Chorka Textile Ltd. (New Building)

28th September 2017

Observations

Column to be stressed above normal design limits

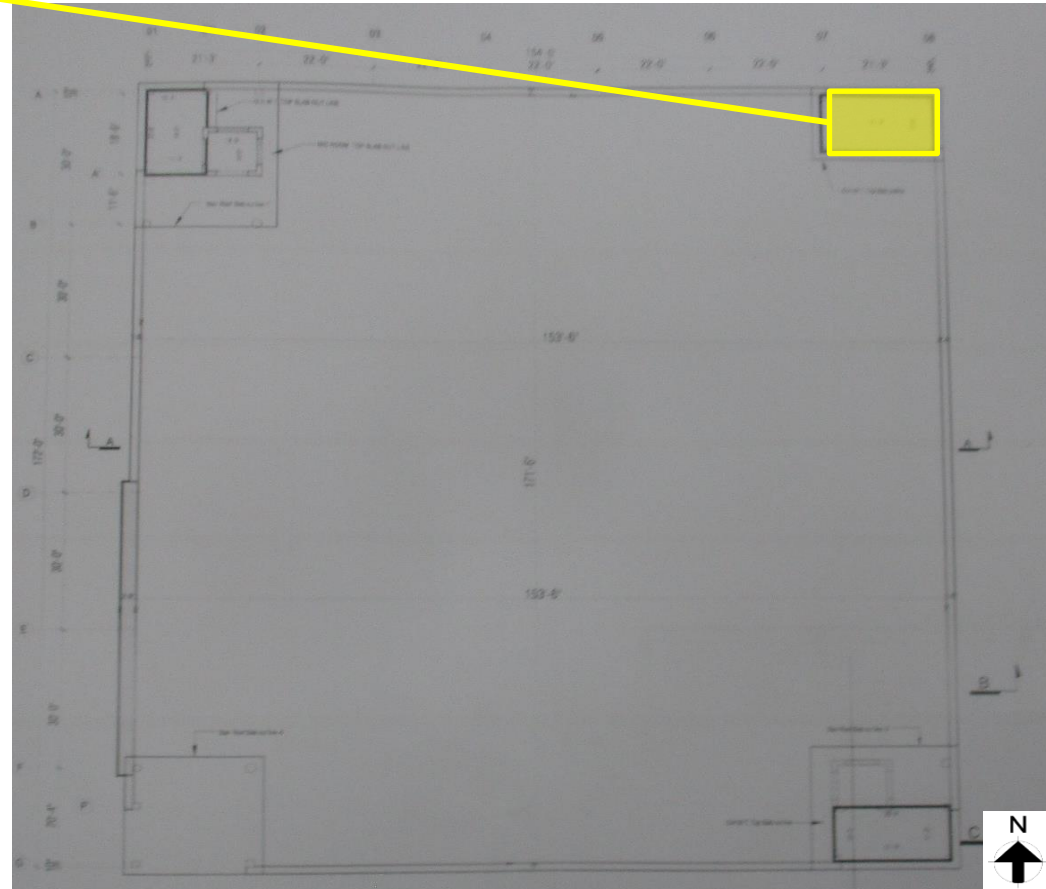
Cursory calculations considering 3kpa (as per provided load plan) indicates that Columns appears to be stressed above normal design limits.

Item No.	Observation	Recommended Action Plan	Recommended Timeline
1	Column to be stressed above normal design limits	Building Engineer to review design, loads and column stresses in area identified above.	6-weeks
2	Column to be stressed above normal design limits	Verify in-situ concrete stresses by 100mm dia. cores from min. 4 no. column from ground floor level.	6-weeks
3	Column to be stressed above normal design limits	Produce and actively manage a loading plan for all floor plates within the factory, giving consideration to floor capacity and column capacity.	6-weeks
4	Column to be stressed above normal design limits	Make any structural alterations as advised by Building Engineer.	6-months
5	Column to be stressed above normal design limits	Continue to implement loading plan.	6-months

Steel column layout plan

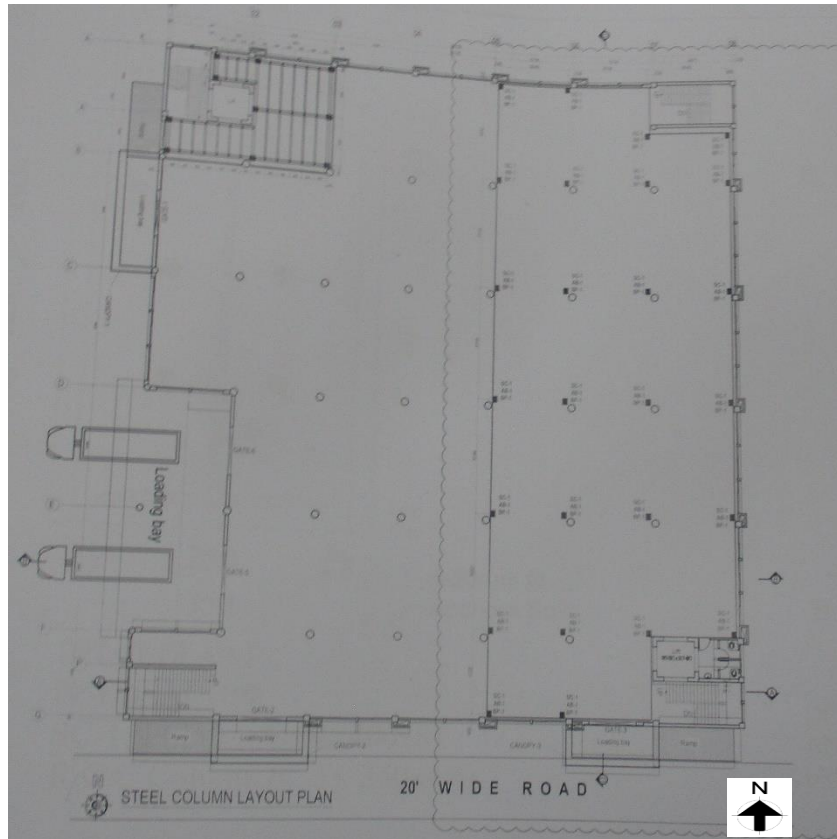
Discrepancies between provided drawings and on site condition for mezzanine portion.

Column sizes are not match with provided as-built drawings. Flange widths were found 240 mm instead of 250 mm in some steel columns at mezzanine floor.

Item No.	Observation	Recommended Action Plan	Recommended Timeline
6	Discrepancies between provided drawings and on site condition for mezzanine portion	Building Engineer to survey as-built structure and prepare accurate as-built survey information for steel part.	6-weeks
7	Bolt missing	Install missing bolts	6-weeks
8	Roof appears not to have any waterproofing system	Waterproofing on the roof slab is to be applied or improved. Moreover the roof slab drainage system should be investigated and improved.	6-weeks
9	Columns susceptible to have vehicle impact	Install a barrier to prevent vehicle impact on column	6-weeks

Bolt missing

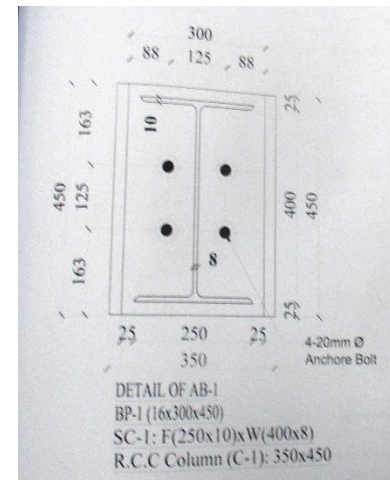
Bolts were missing in several location at sub-beam & main beam connection.

**Roof appears not to have any
waterproofing system**

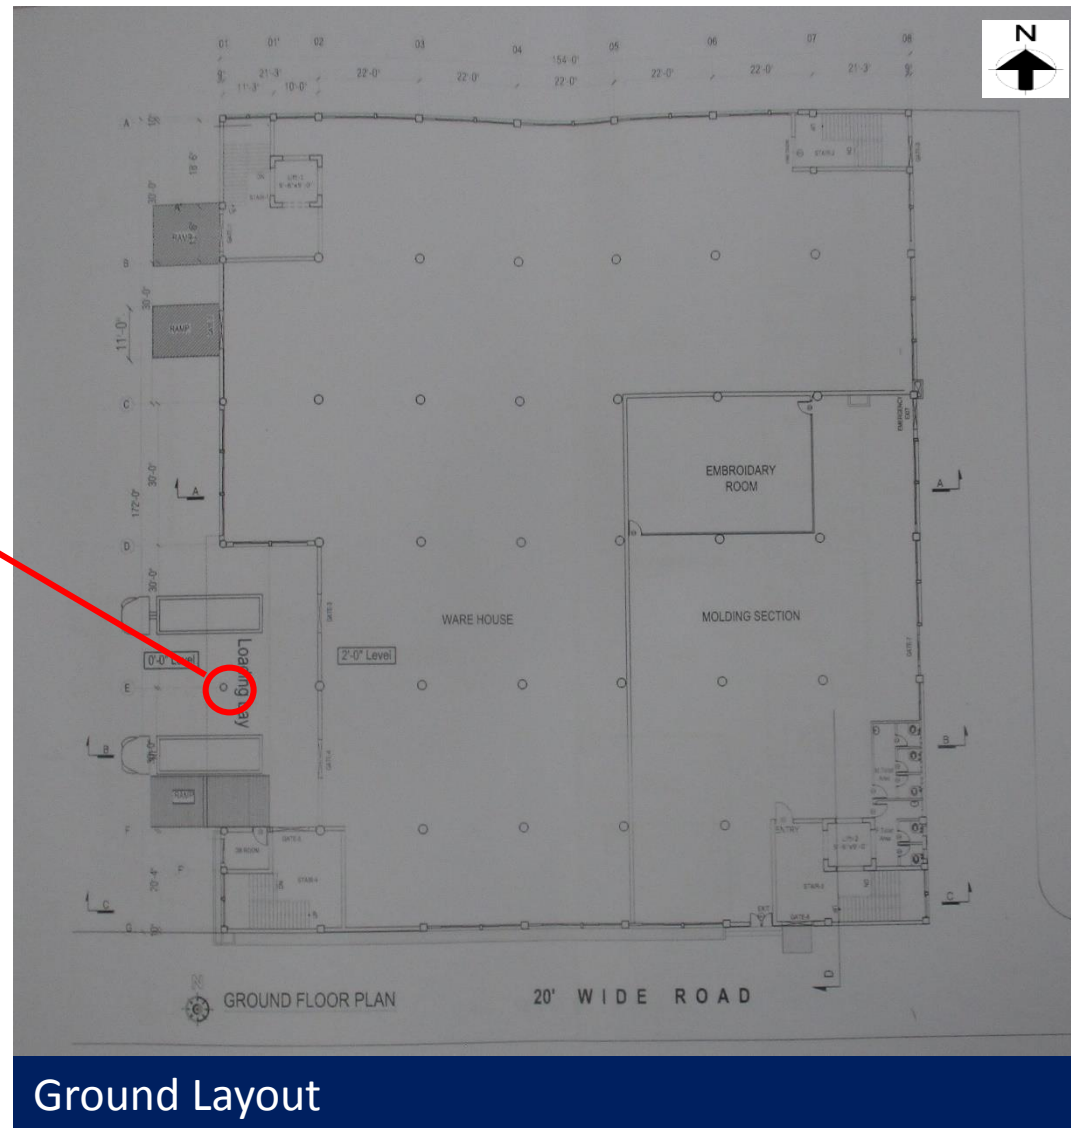
During inspection water ponding observed on roof. Factory engineer is required to check that roof finishes have been installed and roof is draining freely.
